**Comments of Powerex Corp. on
Report on Proposed EIM Greenhouse Gas Enhancements**

Submitted by	Company	Date Submitted
Mike Benn 604.891.6074	Powerex Corp.	December 18, 2017

Figure 5. Example of Flawed GHG Attribution Under Current EIM Algorithm: September 15, 2017 HE7, FMM Interval 3

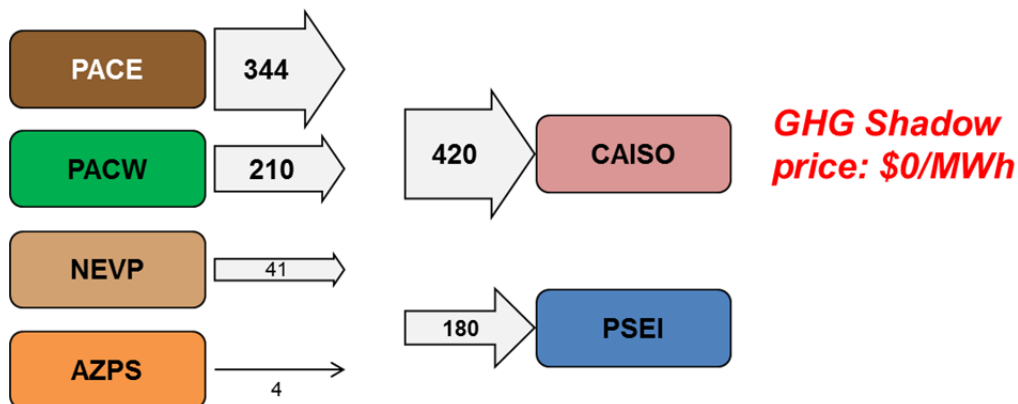
The skewed attribution under the current EIM algorithm is powerfully illustrated by examining a single interval in detail. Figure 5 shows the EIM transfers for each BAA for September 15, 2017, HE7, FMM Interval 3:

Mathematically, it appears clear that at least *some* of the exports from the PacifiCorp East BAA *must* be serving load in the CAISO BAA during this interval. The resources in the PacifiCorp East BAA consist primarily of coal and natural gas-fired generation. The price in the PacifiCorp BAA during this interval was approximately \$40/MWh, suggesting it was indeed coal or natural gas resources that were likely increasing their production to support EIM transfers to California (and would be the resources reducing their production if there were no EIM transfers serving California load in this interval). But in this interval, *all* of the imports serving load in the CAISO BAA were deemed to be from “non-emitting” resources, as evident from the GHG shadow price of \$0/MWh.

Figure 6. Example of eligible quantity that can be deemed delivered to CAISO load

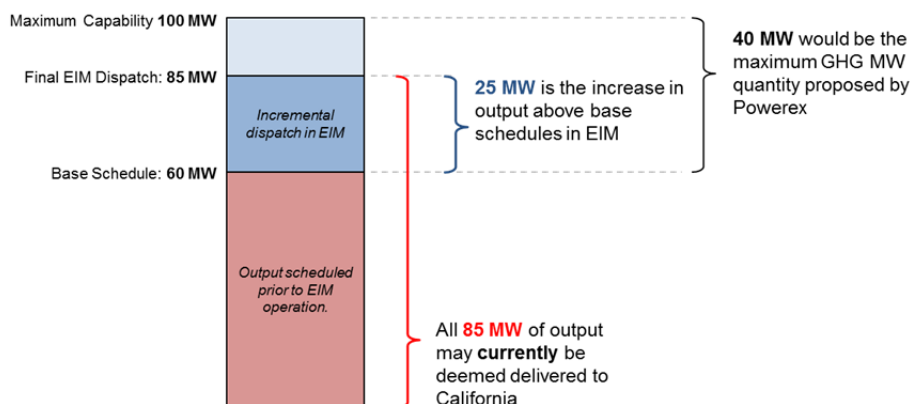
The above example shows a hypothetical 100 MW resource. The resource has a maximum capacity of 100 MW, with 60 MW of its output base-scheduled to serve load outside the EIM. Under the current approach in the EIM, the seller of this resource’s output could elect to make

up to the full 100 MW of capacity eligible to be deemed delivered to serve California load in the EIM (*i.e.*, by submitting a GHG MW quantity of up to 100 MW). In the above example, this may result in the resource being deemed delivered to California for its full dispatched output of 85 MW, even though it has only increased its production by 25 MW above its base schedule. If this is a non-emitting resource, it is much more likely that it will indeed be deemed delivered to California for its full 85 MW of output, thereby enabling external emitting resources to increase their production and serve California load (without properly applying these resources GHG-related costs in the dispatch and pricing of the EIM, and without applying CARB reporting and GHG allowance obligations). Powerex's proposed improvement would simply limit the quantity that could be deemed delivered to California to the "headroom" of 40 MW, which is the amount the resource could increase its production above the base-scheduled quantity that has already been identified as serving load outside the EIM. While this still enables the resource to be deemed delivered to serve California load for 40 MW when it has only increased its production by 25 MW, it would be a significant improvement over the *status quo*.

Powerex believes that the accuracy of the GHG attribution in the EIM could be significantly improved by simply limiting the GHG MW quantity that can be submitted for each resource. EIM participating resources currently have the discretion to submit *any* GHG MW quantity between a minimum value of 0 MW and a maximum value equal to the resource’s maximum output. Powerex believes this discretion is excessive, as it allows up to 100% of a resource’s output to be deemed to serve CAISO load, regardless of how much of the resource’s output is due to its dispatch in the EIM. Powerex recommends that the GHG MW quantity submitted for a resource should be limited to the portion of the resource’s maximum output above its EIM base schedule quantity. That is, a resource could only be deemed to serve CAISO load for a quantity that is equal or less than its “headroom” above its base schedule.

Powerex believes that limiting GHG MW quantities to a resource's "headroom" above base schedules will significantly reduce the discretion with which the EIM algorithm deems output to serve CAISO load. This proposal will more closely align GHG attribution in the EIM to the EIM's dispatch of resources, which Powerex believes is a more valid basis for specified-source reporting of imports under CARB's cap-and-trade program. Powerex does not claim that this proposal will be precisely as accurate as the proposed two-pass solution, or that it would be the optimal long-term solution. Indeed, both Powerex's proposal to limit a resource's GHG MW quantity to its "headroom" as well as the proposed two-pass solution will likely result in a material remaining understatement of GHG emissions in the EIM's dispatch solution. Powerex does believe, however, that its proposed approach will result in significantly more accurate GHG attribution in the EIM compared to the current algorithm, is much more appropriate than the *status quo*, and can be implemented with limited effort or delay. This approach can be replaced and/or supplemented, if and when a longer-term solution or enhancements are developed.

Figure 7. Same Calculation of Incremental GHG Emission Rate of EIM Transfers to CAISO Load

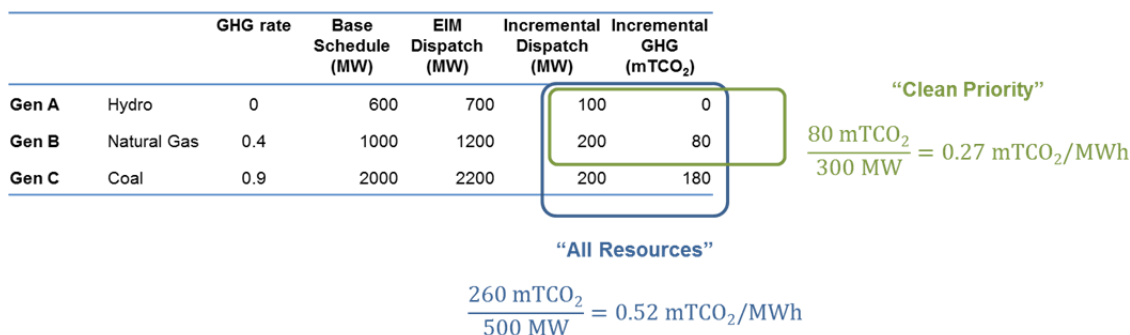
Consider an interval with 300 MW of EIM transfers serving CAISO load. In this interval, there is a total of 500 MW of resource output in excess of base schedules, including 100 MW from a non-emitting hydro plant, 200 MW from a natural gas generator (with a GHG emission rate of 0.4 mTCO₂/MWh), and 200 MW from a coal-fired generator (with a GHG emission rate of 0.9 mTCO₂/MWh). Figure 7 shows two possible approaches to calculating the average GHG emission rate associated with the 300 MW of EIM transfers serving CAISO load. The first method, labeled “All Resources,” is simply based on the weighted average of all out-of-state resources that are dispatched above base schedules, weighted by the amount of incremental dispatch. The second method, labeled “Clean Priority,” assigns incremental dispatch to the EIM transfers serving CAISO load from each resource in order of emission rate. This second method may be viewed as a lower bound on GHG emissions associated with serving CAISO load, while recognizing that not all resource output above base schedules is due to transfers to CAISO.

Powerex believes that it should be relatively straight-forward for CAISO to perform an analysis of this issue. More specifically, CAISO has data regarding each resource’s EIM dispatch and each resource’s base schedules. For each interval that the CAISO BAA was a net importer in the EIM, the CAISO could calculate the average GHG emission rate for all out-of-state resources that were dispatched above their base scheduled quantity.

The above would yield the GHG emission rate of EIM transfers to CAISO load in a given interval. Each interval within a given period (e.g., month or year) would then be weighted based on the volume of EIM net imports into the CAISO BAA for that interval.
